HISTORIC AND DESIGN REVIEW COMMISSION

December 19, 2018

HDRC CASE NO: 2018-623
ADDRESS: 119 E KINGS HWY
LEGAL DESCRIPTION: NCB 3257 BLK 1 LOT 8&9
ZONING: R-5,H
CITY COUNCIL DIST.: 1
DISTRICT: Monte Vista Historic District
APPLICANT: Troy Jessee
OWNER: Scott and Cassandra Leune
TYPE OF WORK: Rear accessory structure modifications
APPLICATION RECEIVED: November 20, 2018
60-DAY REVIEW: January 19, 2018
REQUEST:

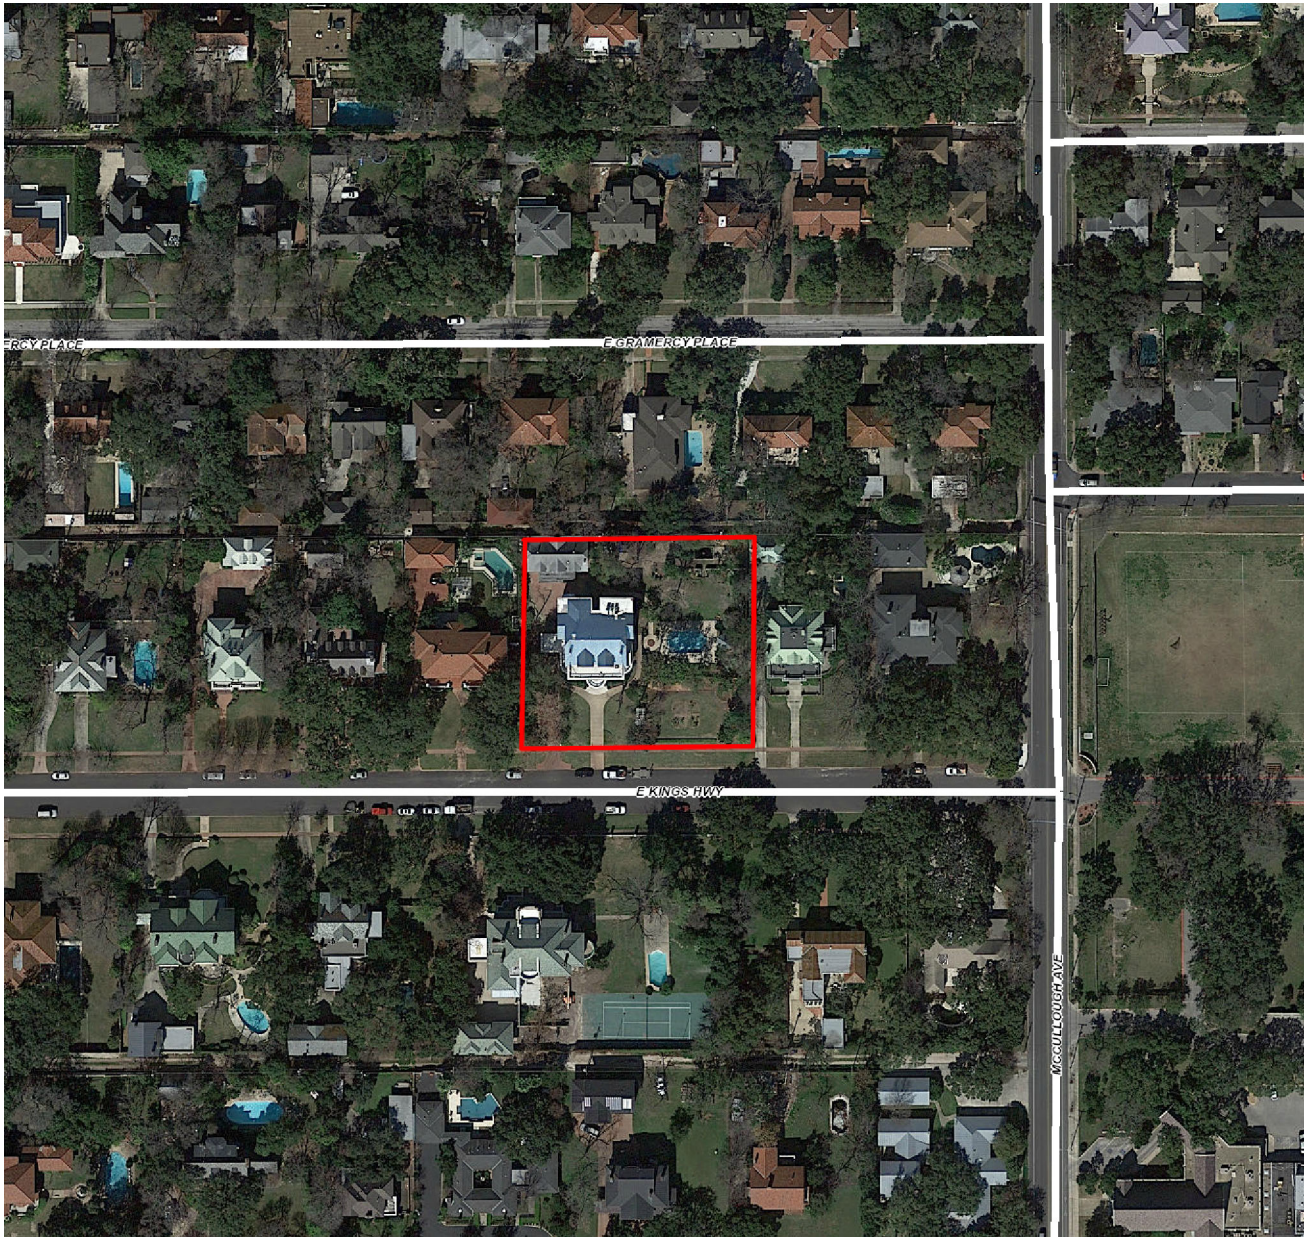
- b. CANOPY REMOVAL – The applicant is requesting to remove the existing canopy from the rear accessory structure. The canopy features three square columns with square brick bases that match the brick on the first floor of the structure and a flat roof. Based on Sanborn Maps from 1911 - 1951, the canopy element is original to the rear accessory structure. According to the Historic Design Guidelines, distinctive features of outbuildings and garages should be preserved. Staff does not find the removal of the canopy consistent with the Guidelines.

- c. GARAGE DOOR REPLACEMENT – The applicant has proposed to replace the existing wooden carriage doors with an in-kind operable door that features lites, detailing, and sizing that matches the existing. Staff finds the request consistent with the Guidelines and eligible for administrative approval.

Item 1, Staff does not recommend approval of the canopy removal based on finding b. Staff recommends that the canopy be retained and restored in place.

Item 2, Staff recommends approval of the garage door replacement based on finding b.
